SIL 4500-02 – Revision B SN4500 Primary Navigation Display Service Information Letter

Regarding: Interfacing with Garmin GNS 400W/500W series receivers

Revision B: Updated interface drawing with revised relay connections to SN4500

Sandel SN4500 interface to Garmin GNS 430W/530W receiver drawing

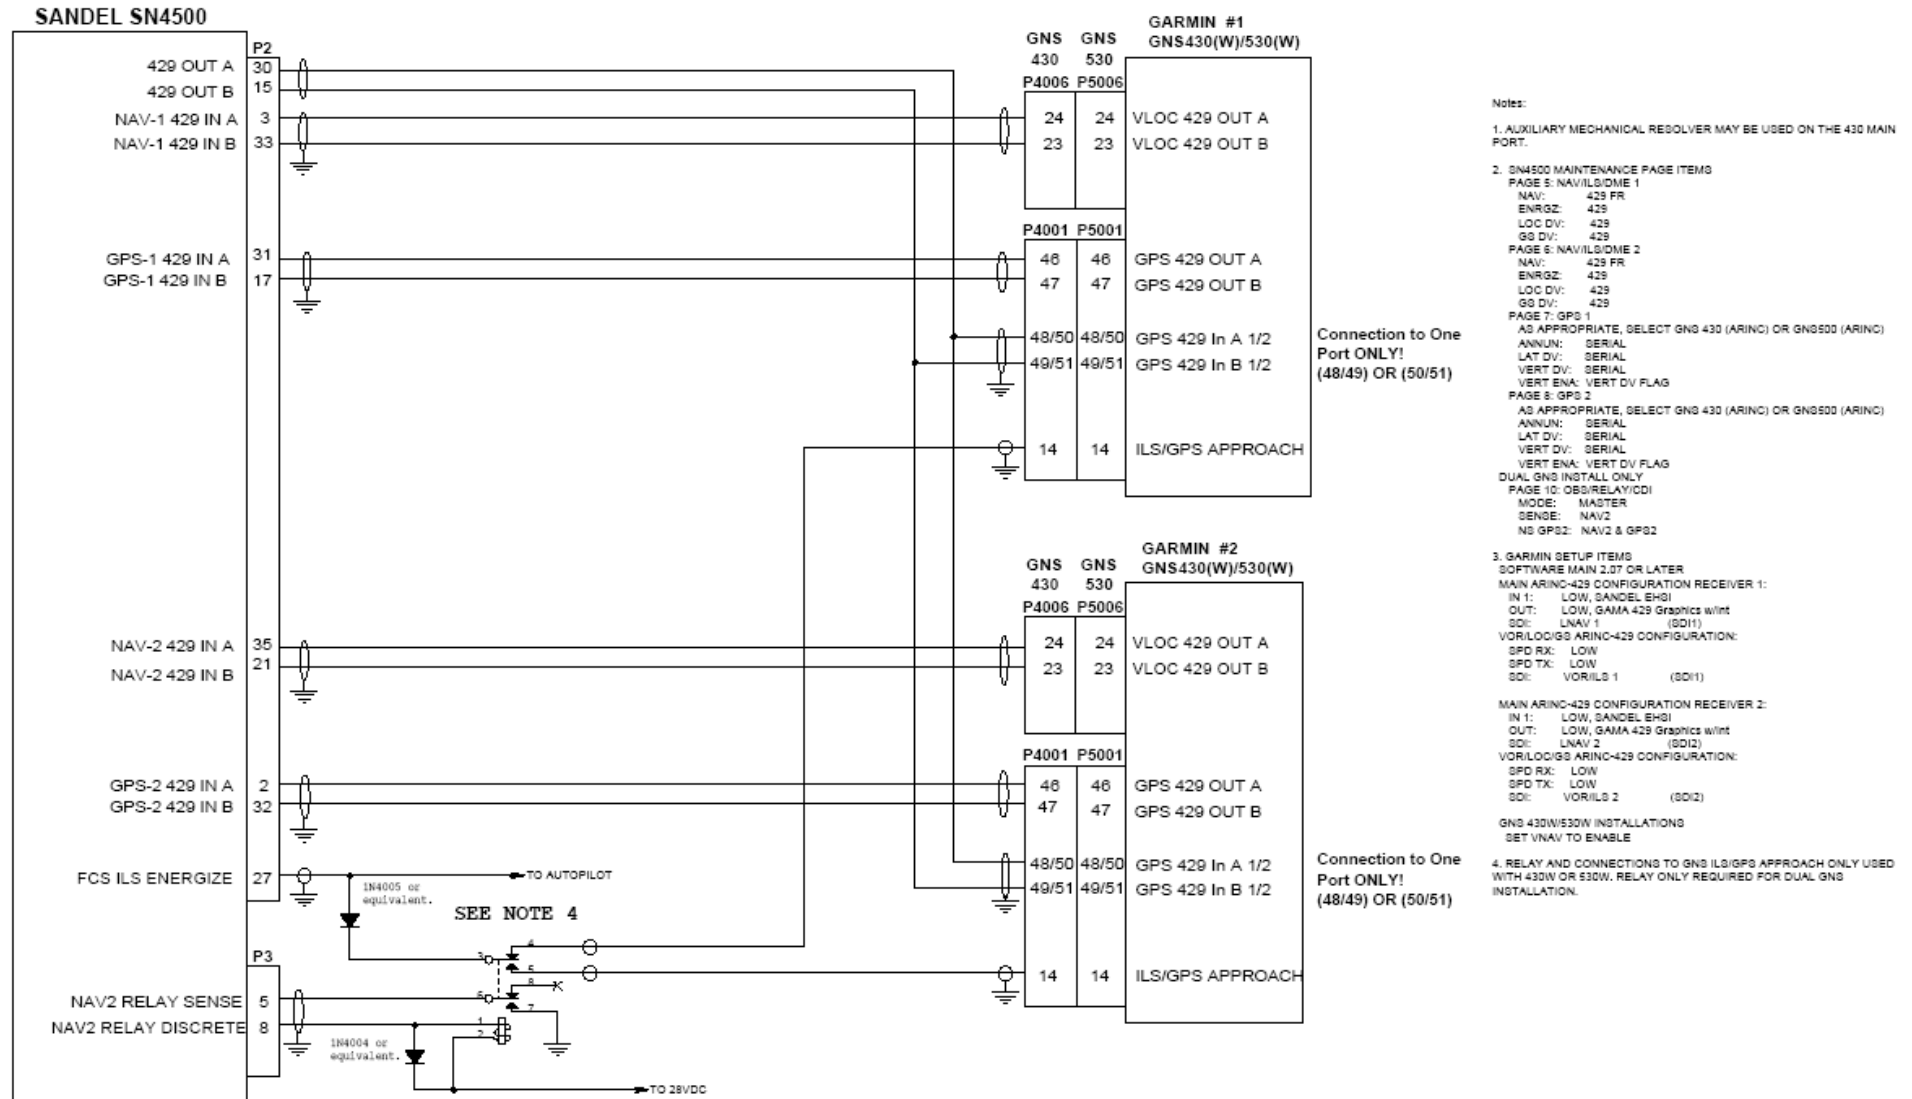
Please refer to the drawing on the following page. It is necessary to jumper the ILS/GPS Approach output from the Garmin GNS 400W/500W to the FCS ILS Energize output, P2-27, of the SN4500 using an isolation diode. A relay will be required if dual GNS 400W/500W receivers are interfaced to the SN4500.
